**D240002: New Zealand Transport Agency Notice of Requirement SH 1 Rolleston Access Improvements (Package 2)**

**Request for further information**

<b>Prepared for</b>	Selwyn District Council
<b>Project Number</b>	SDC-J084
<b>Revision</b>	A
<b>Issue Date</b>	10 December 2024
<b>Prepared by</b>	Mat Collins, Associate Transportation Planner; Dave Smith, Technical Director - Transportation Planning
<b>Reviewed by</b>	Dave Smith, Technical Director - Transportation Planning

Discipline: CIVIL ENGINEERING  
Drawing No: 3338703-20-CU-3522  
Rev: A

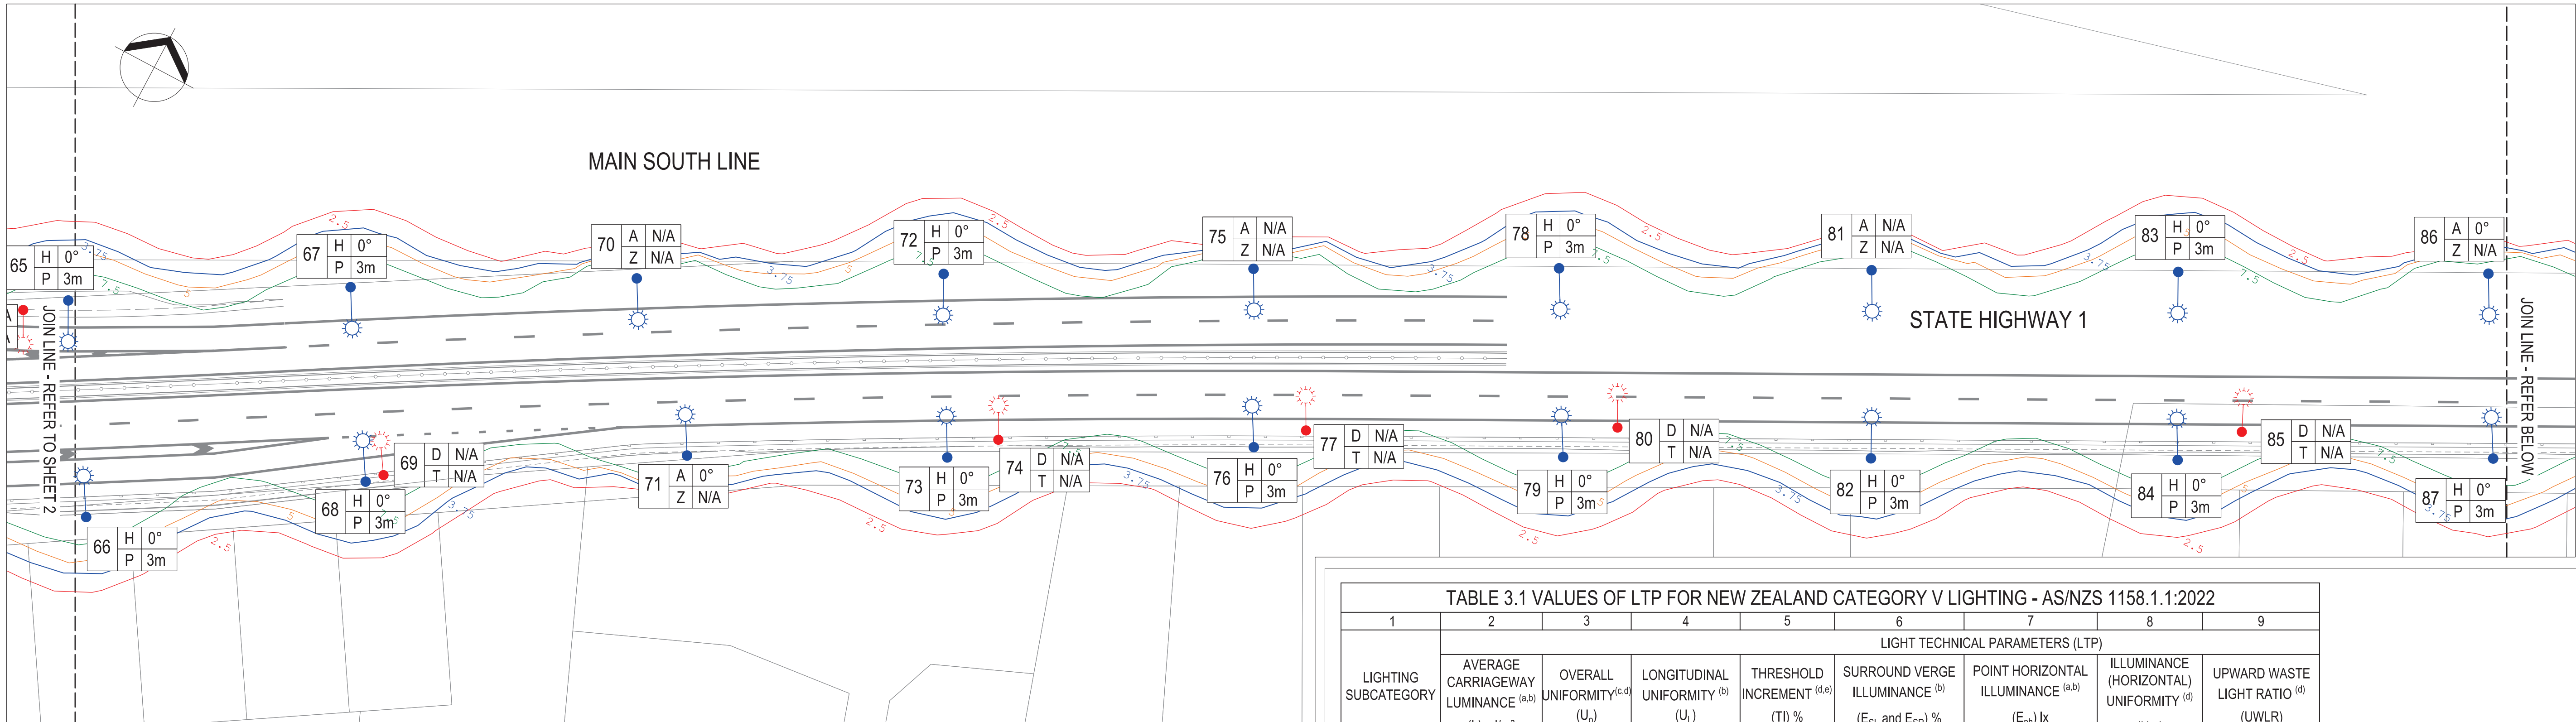
15. Drawing 3338703-20-CU-3522 – Same comment as Item 5 above. *Please get the lighting designer to change the lane directional descriptions so that they align with the true geographic direction. Please get the designer to include illuminance calculations for the westbound merging lanes.*

16. Drawing 3338703-20-CU-3522 - Calculation Summary table presents illuminance and uniformity calculations for the diverging and merging gore areas and the sharp bend, but these appear to be limited to the carriageway areas...where are the calculations for the surrounds? *Please get the lighting designer to provide calculations for all applicable design areas (carriageways and surrounds) at all locations in accordance with AS/NZS 1158.1.1 Figures 4.2, 4.4, 4.5 and 4.8.*

Should this be WESBOUND DIVERGENCE? to line with the geographic north symbol

Where are the illuminance calculations for the surrounds?

Drawing No: 3338703-20-CU-3523

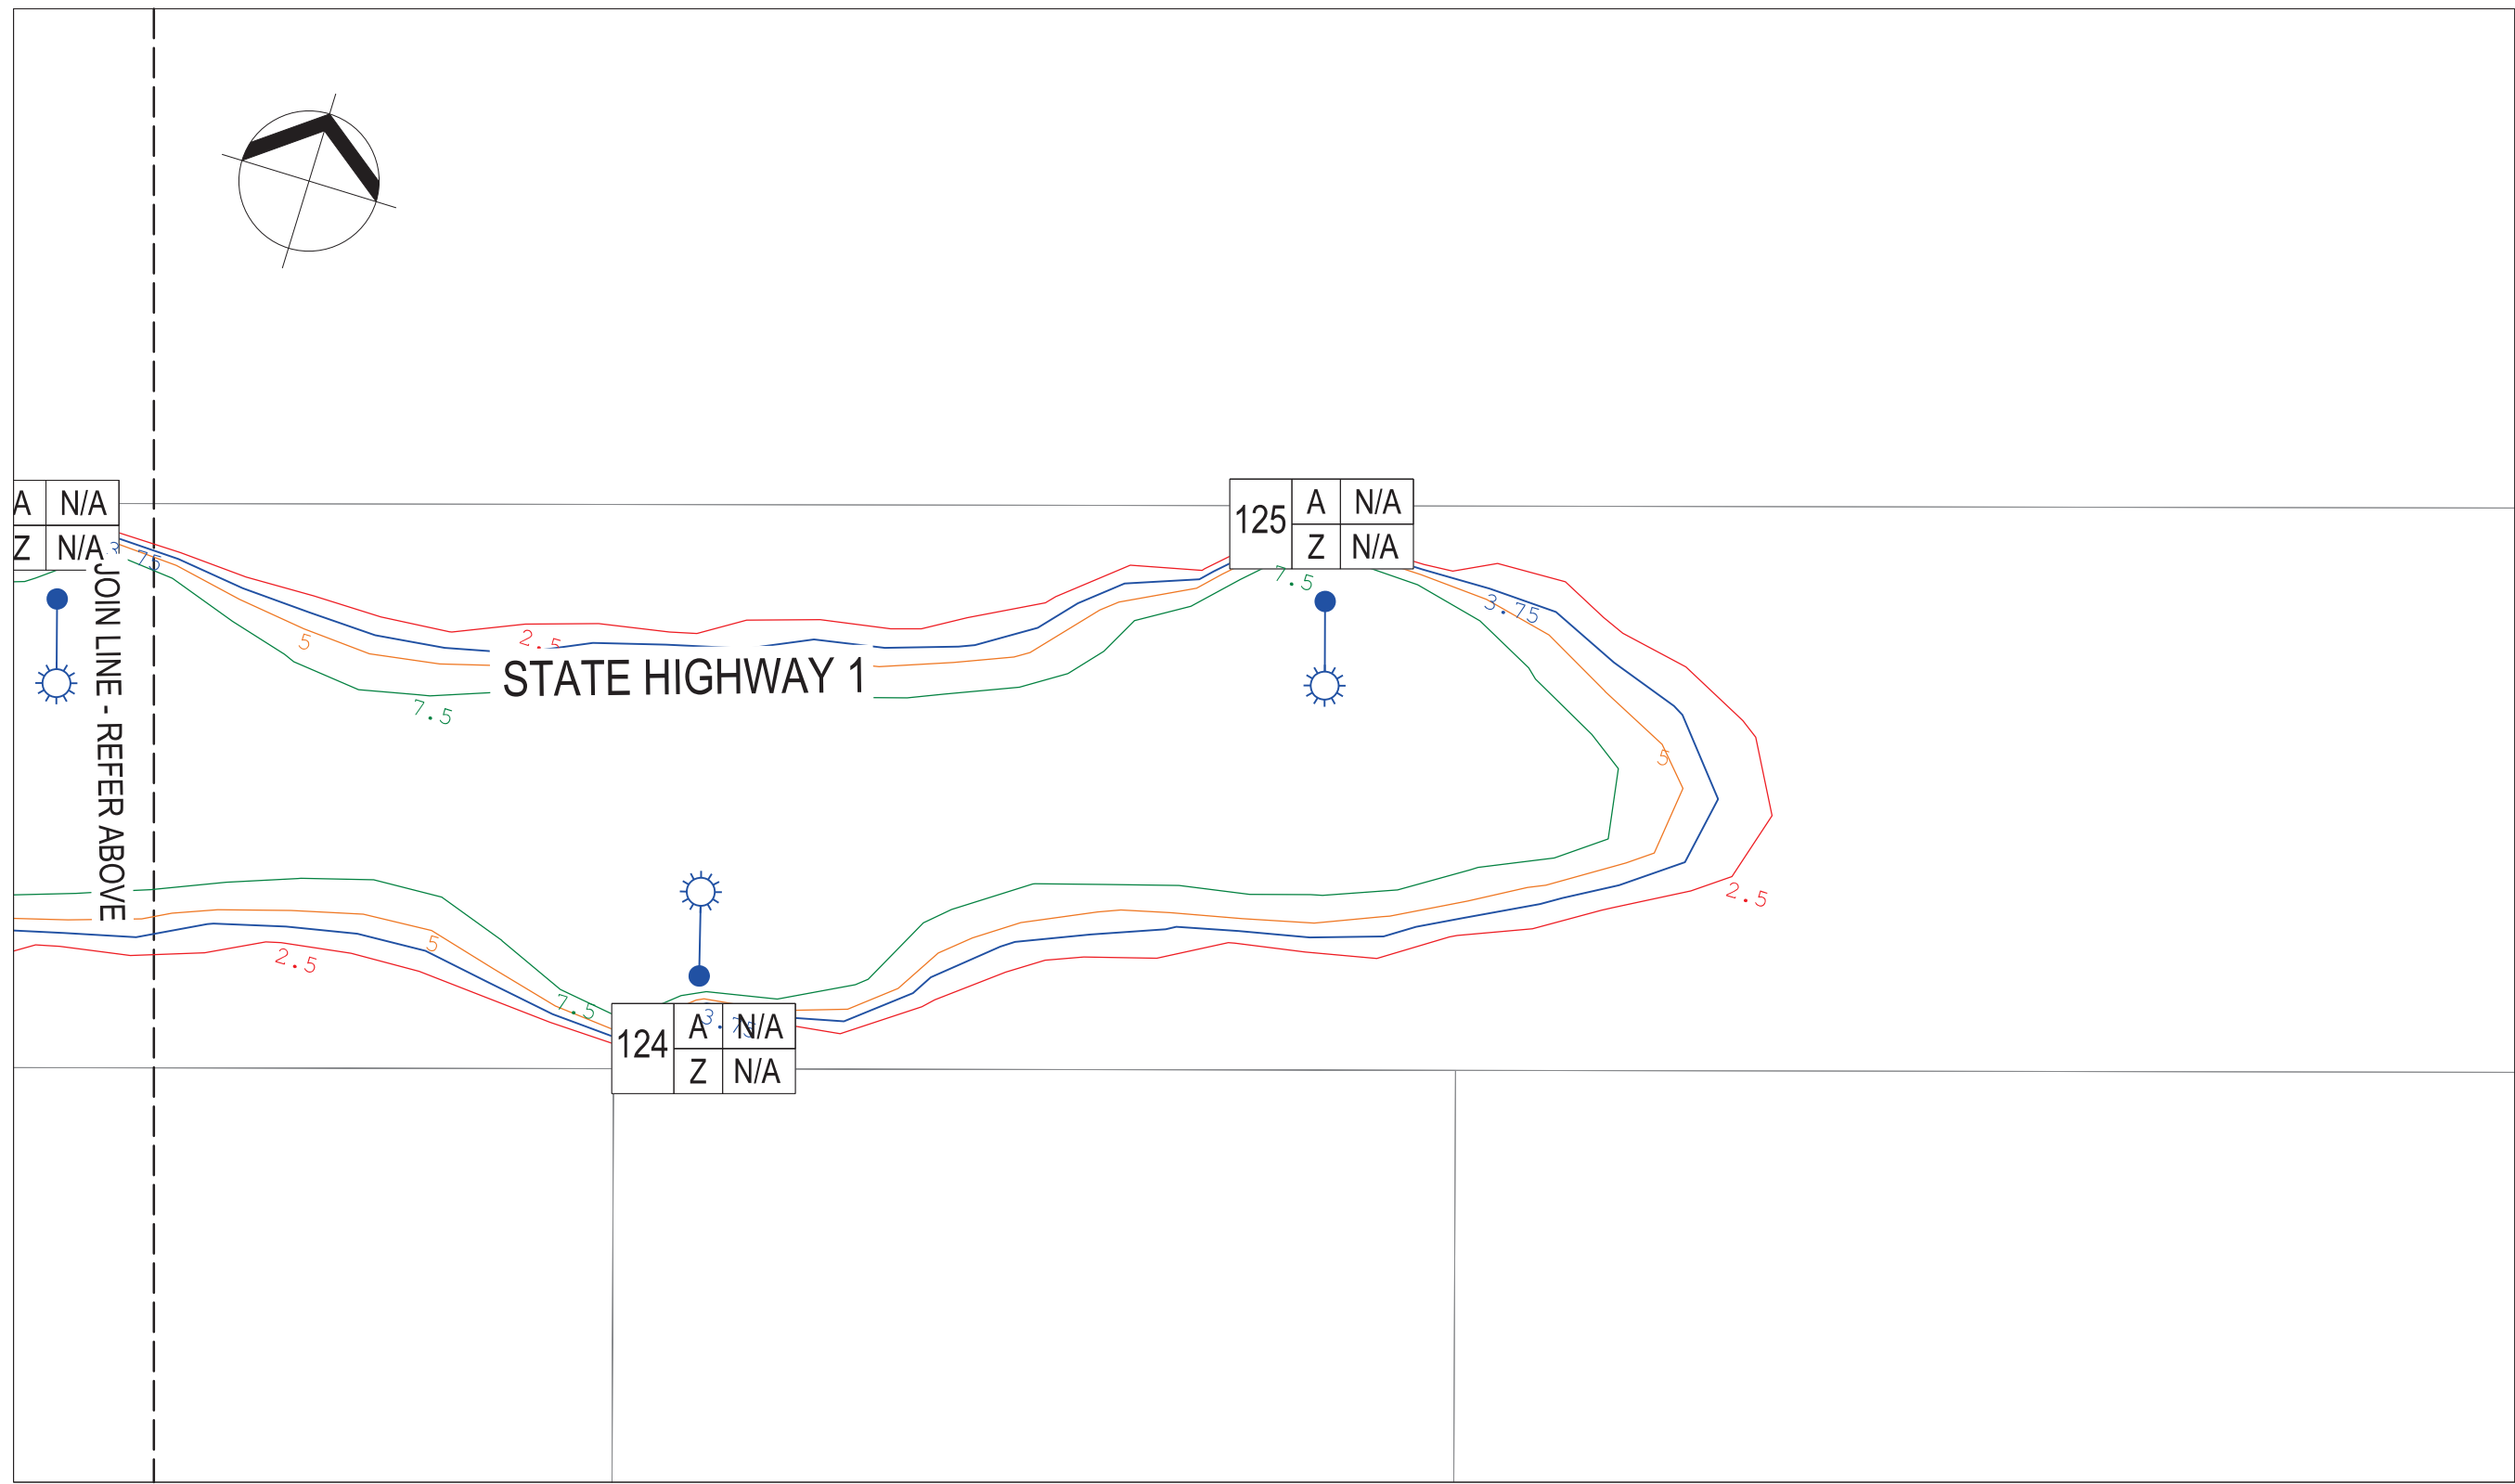
17. Drawing 3338703-20-CU-3523 - Calculation Summary table presents illuminance and uniformity calculations for the SH1 southbound diverging lanes, but according to the north symbol on the drawing the diverging lanes are going in a westerly direction. *Please get the lighting designer to change the lane directional description so that it aligns with the true geographic direction.*

18. Drawing 3338703-20-CU-3523 - Calculation Summary table presents illuminance and uniformity calculations for the diverging lanes, but these appear to be limited to the carriageway areas...where are the calculations for the surrounds? *Please get the lighting designer to provide calculations for all applicable design areas (carriageways and surrounds) in accordance with AS/NZS 1158.1.1 Figure 4.2.*

Discipline:	CIVIL ENGINEERING
Drawing No.	3338703-20-CU-3525
Rev.	A

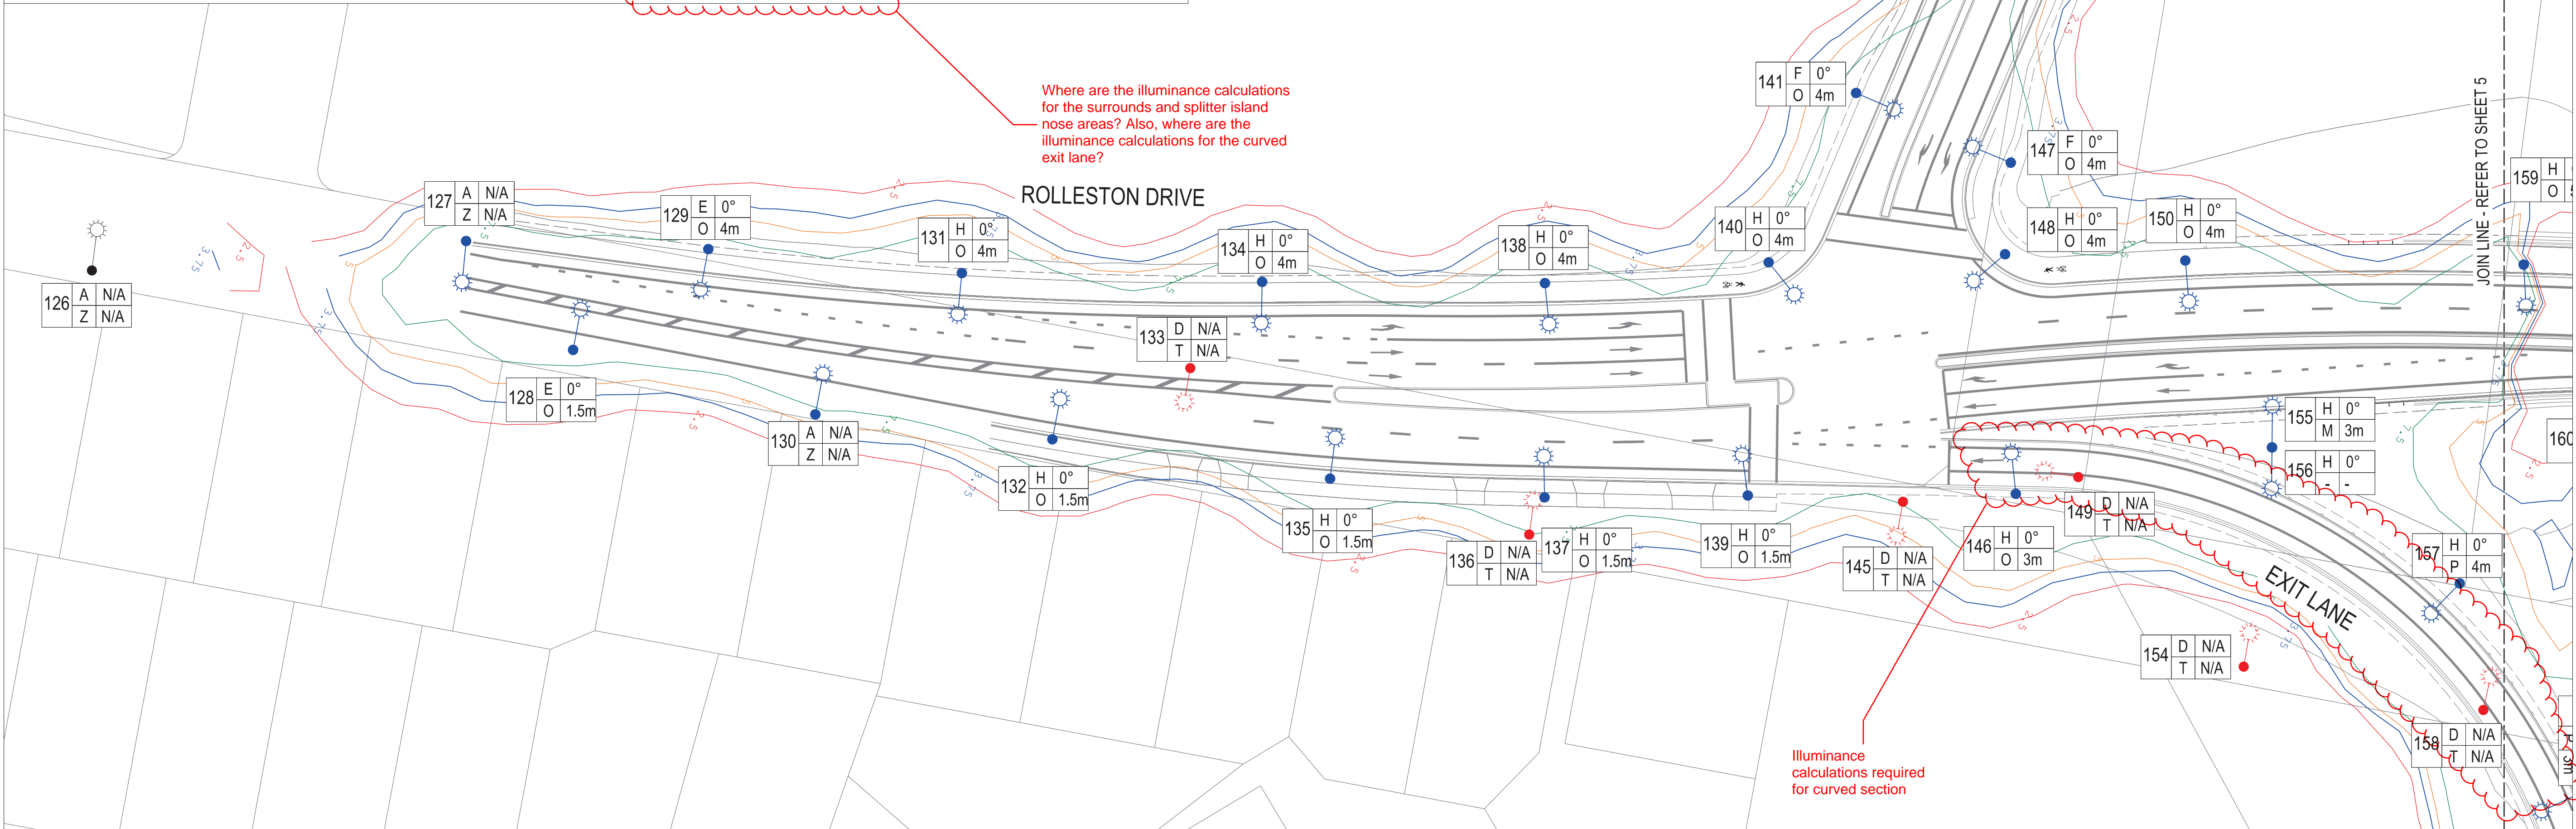
19. Drawing 3338703-20-CU-3525 - Calculation Summary table presents one set of luminance calculation results per road, but what lane configurations do these calculations apply to? For Kidman St, the eastbound side goes from a single lane to double lanes with one lane on the westbound side; and for Rolleston Dr there is a single lane diverging to three lanes on the northbound side and two lanes merging into one on the southbound side. There needs to be multiple luminance calculations to account for the different lane configurations. *Please get the lighting designer to confirm that the luminance calculations apply to all of the lane configurations (multilane divided carriageways) or supply additional calculation results to cover all arrangements.*

20. Drawing 3338703-20-CU-3525 - Calculation Summary table presents illuminance and uniformity calculations for two intersections and the diverging/merging lanes, but these appear to be limited to the carriageway areas...where are the calculations for the surrounds and splitter island nose areas? Also, where are the illuminance calculations for the curved exit lane? *Please get the lighting designer to provide calculations for all applicable design areas (carriageways and surrounds) at all locations in accordance with AS/NZS 1158.1.1 Figures 4.2, 4.3, 4.4, 4.5, 4.8 and 4.10.*

What lane configuration(s) do these calculations apply to? e.g. Kidman St goes from single lane to double lane on the eastbound side with only one lane on the westbound side; and Rolleston Dr goes from single lane to three lanes on the northbound side and two lanes merging into one lane on the southbound side.

Where are the illuminance calculations for the surrounds and splitter island nose areas? Also, where are the illuminance calculations for the curved exit lane?

Illuminance calculations required for curved section
